RE: Wall Removal  
Boise, ID  
Project: 15014.L01

After reviewing the architectural plans of the Woodbine at Lakewood condominiums, it is our opinion that it may be possible to remove a portion of the walls in question, conditional upon contractor verification of as built condition.

Figure 1

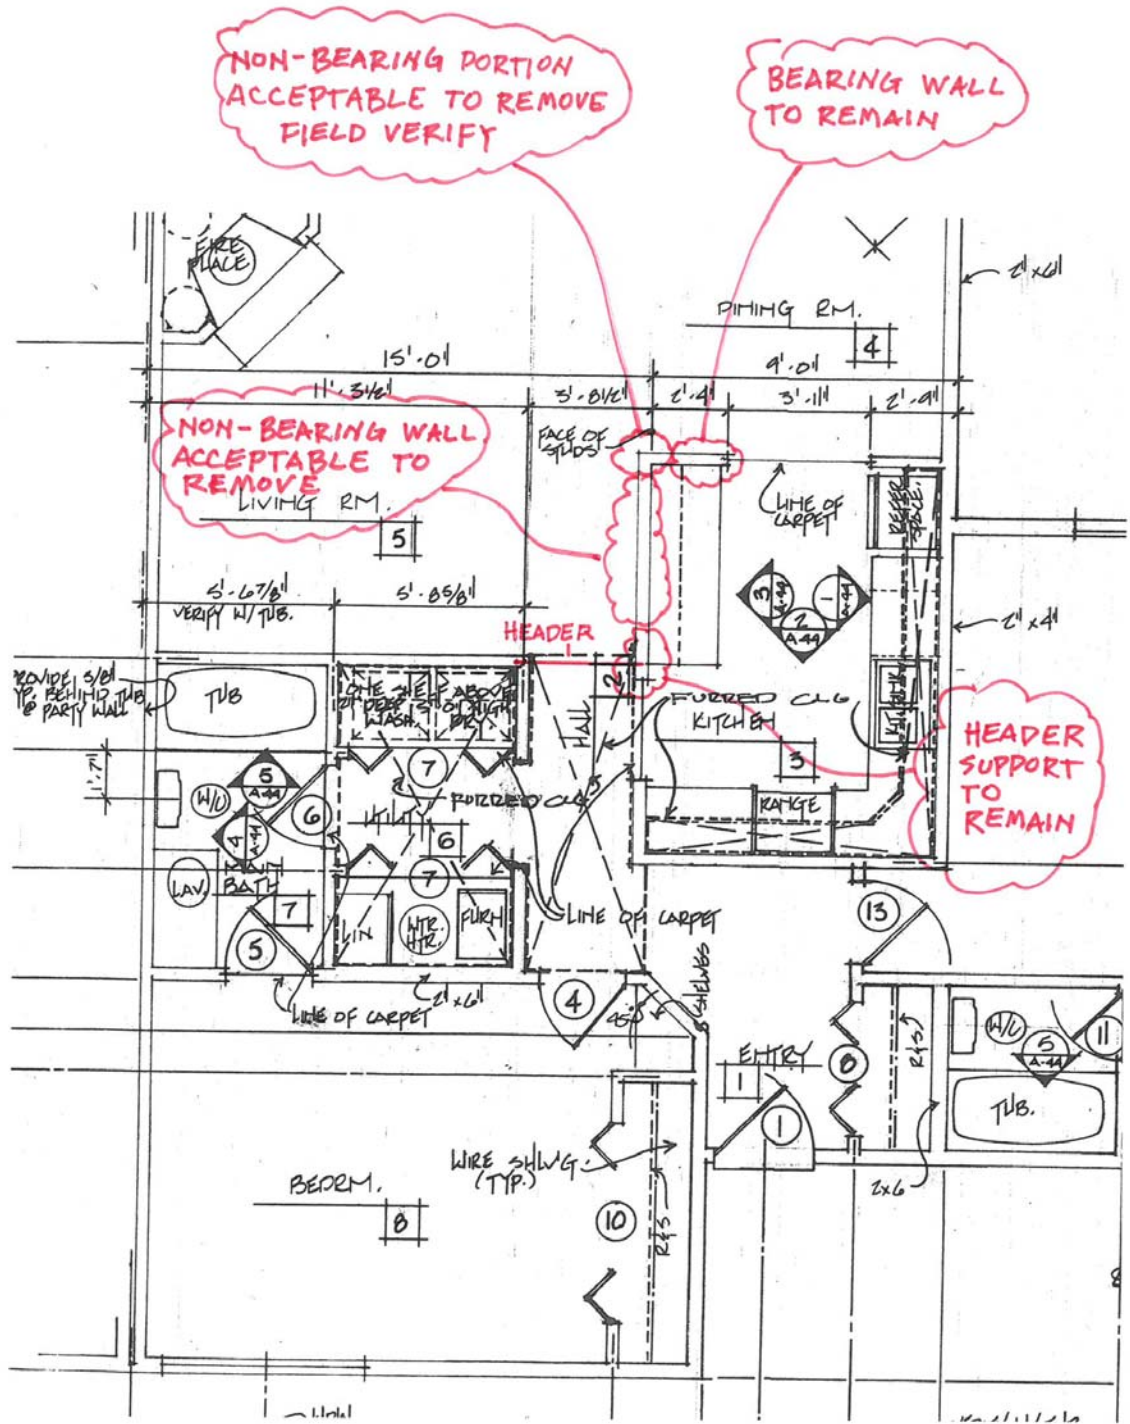
A portion of the wall between the Kitchen and the Living Room may be removed. The support for the header over the Hall must be left intact. See Figure 1.

The wall between the Kitchen and the Dining Room is a bearing wall. Any portion of this wall providing support for the joists above must remain. The portion of this wall between the first joist over the Living Room and the first joist over the Kitchen may be removed. If the first joist over the kitchen is located as far as possible from the corner, based on a joist spacing of 24 inches, the maximum length of wall that would be acceptable to be removed would be approximately 20 inches. If the first joist over the kitchen is located near the corner of the wall in question, none of this wall may be removed. Contractor shall field verify condition prior to wall removal. See Figure 1.
